Origination Form
Proposed Revisions to a Standard Plans Index

| Originator: | Gibbs, Shae | Index Number: | 711-003 |
| E-mail: | shae.gibbs@dot.state.fl.us | Index Title: | Interchange Markings |

TYPICAL CURVED EXIT RAMP

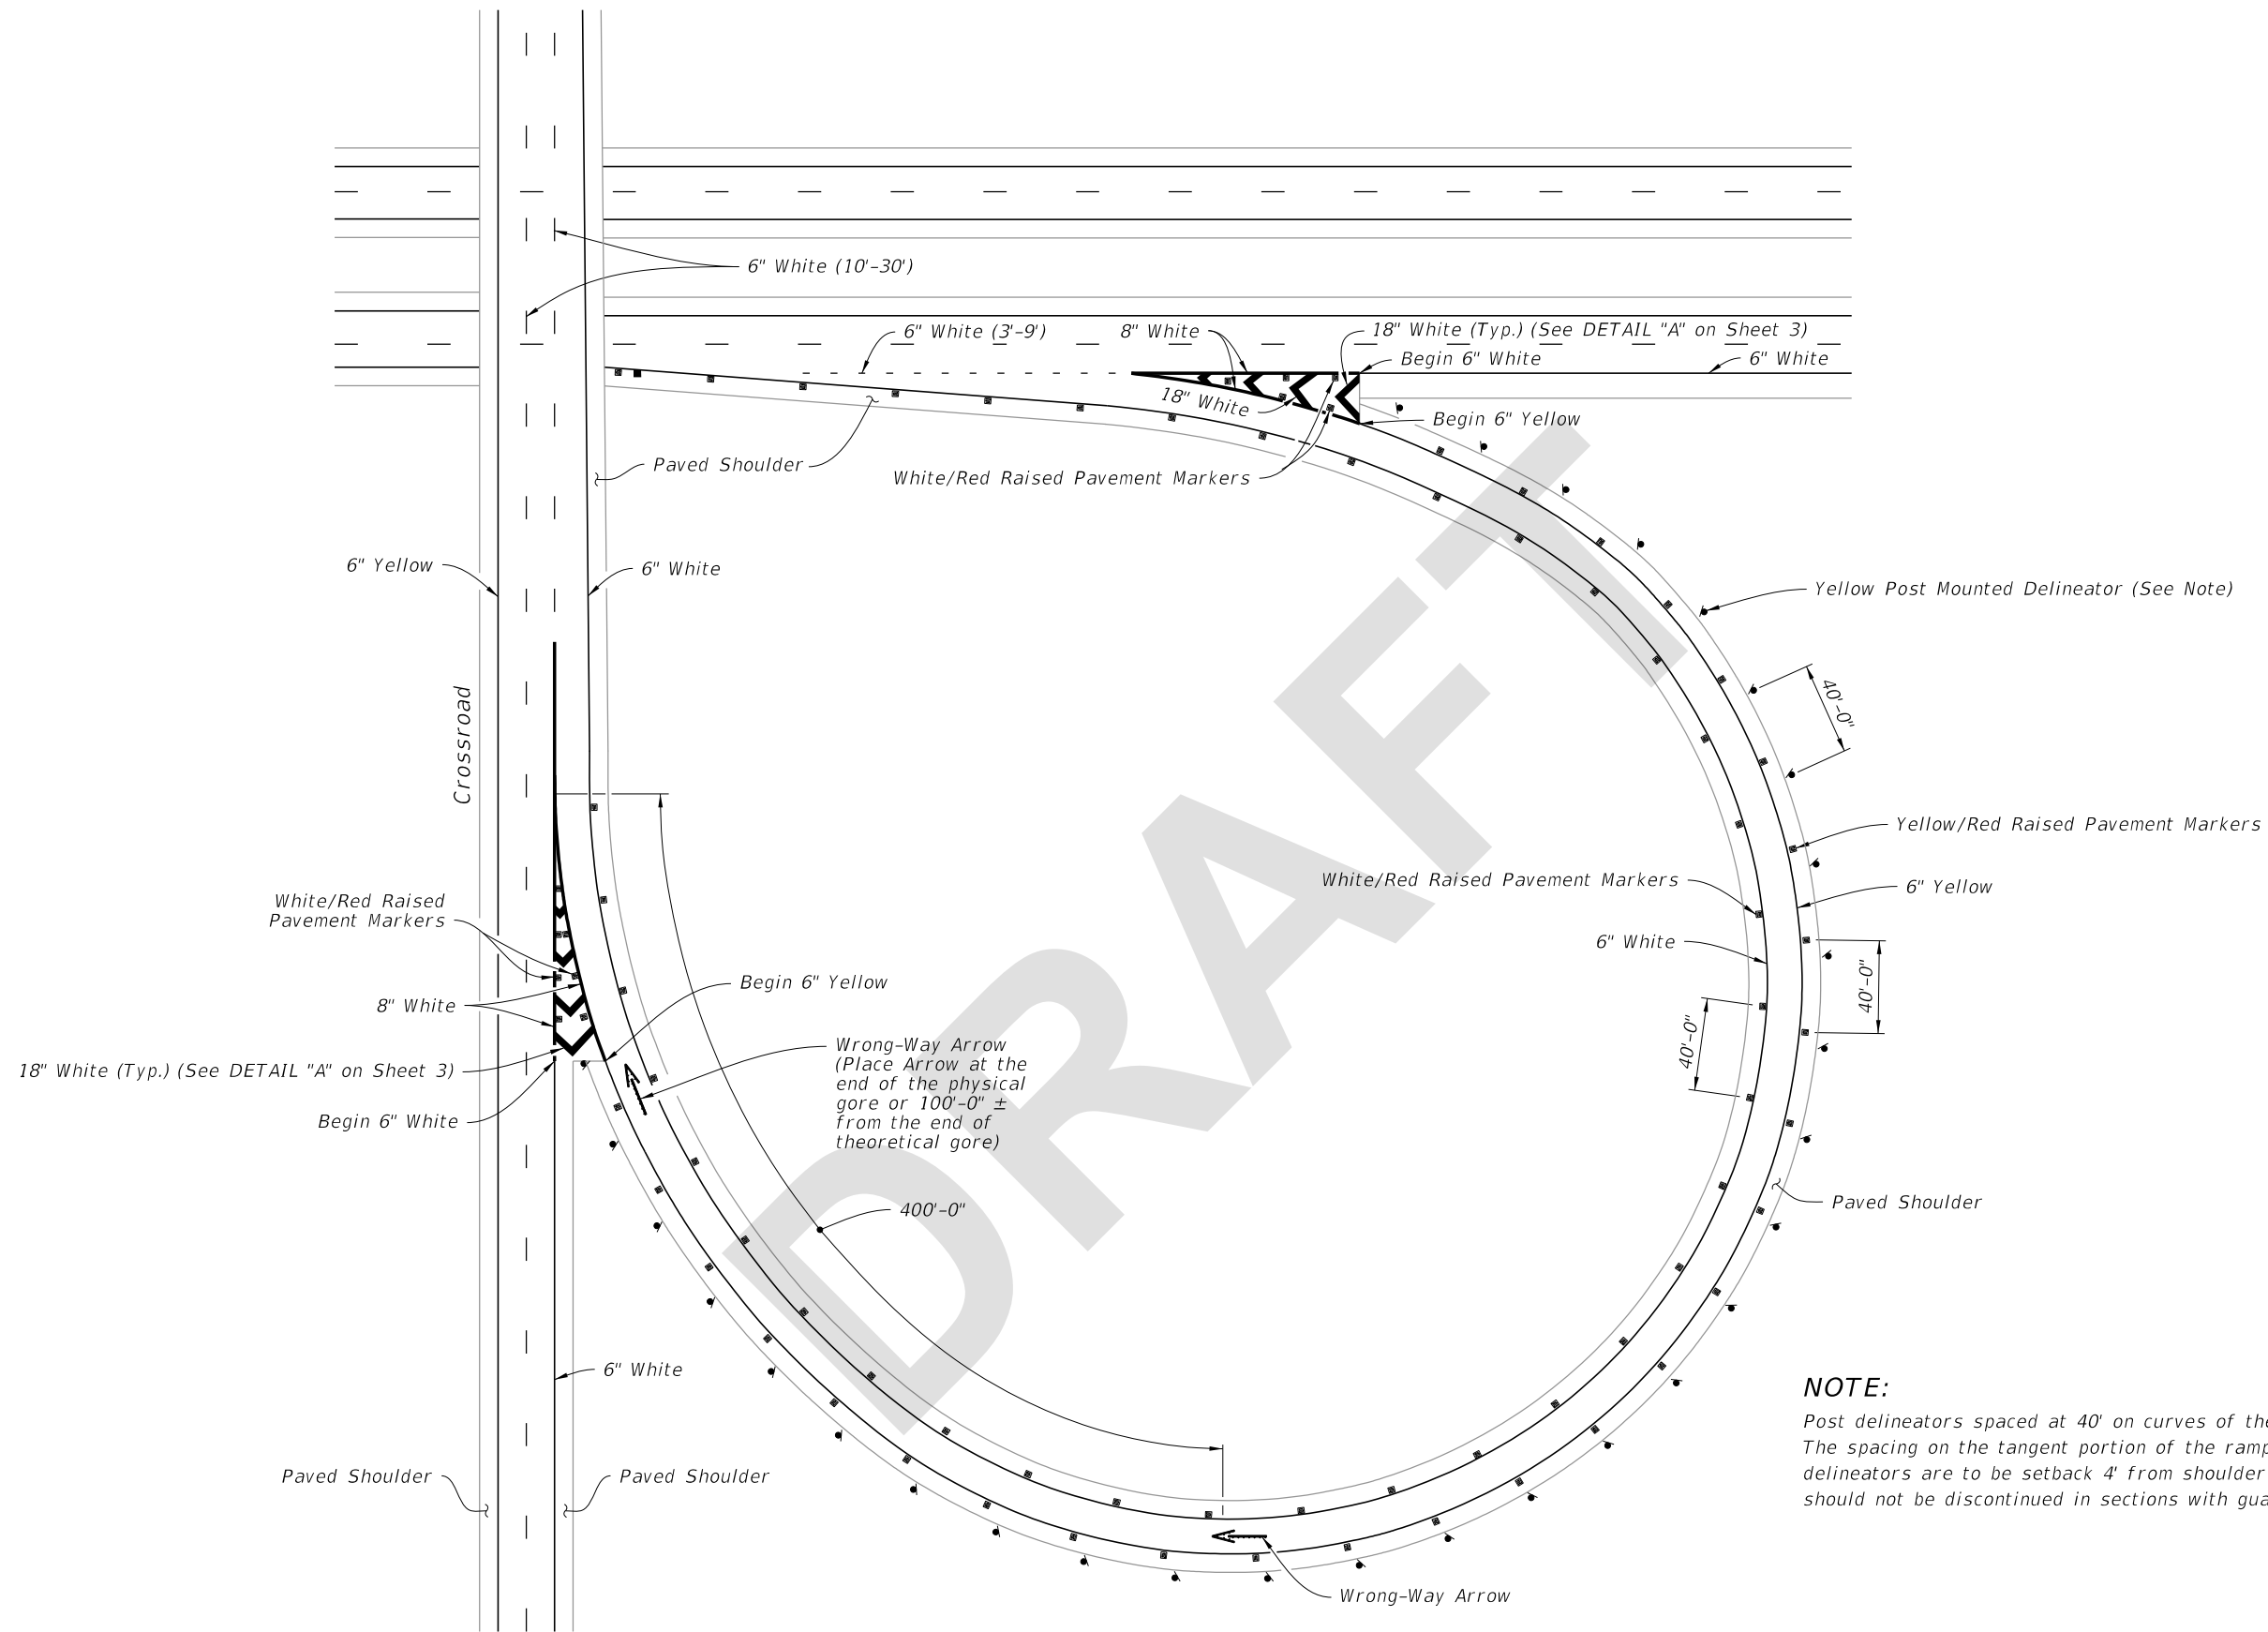
Sheet 2: Added SINGLE-LANE PARALLEL-TYPE ENTRANCE WITHOUT ADDED LANE detail.
Sheet 5: Updated wrong-way arrows to match 706-001.
Sheet 6: Updated wrong-way arrows to match 706-001.
Sheet 7: Updated wrong-way arrows to match 706-001, removed edge line markings from crosswalk areas.

Sheets 5, 6, and 7: Update WWD Arrows to match proposed revision to 706-001
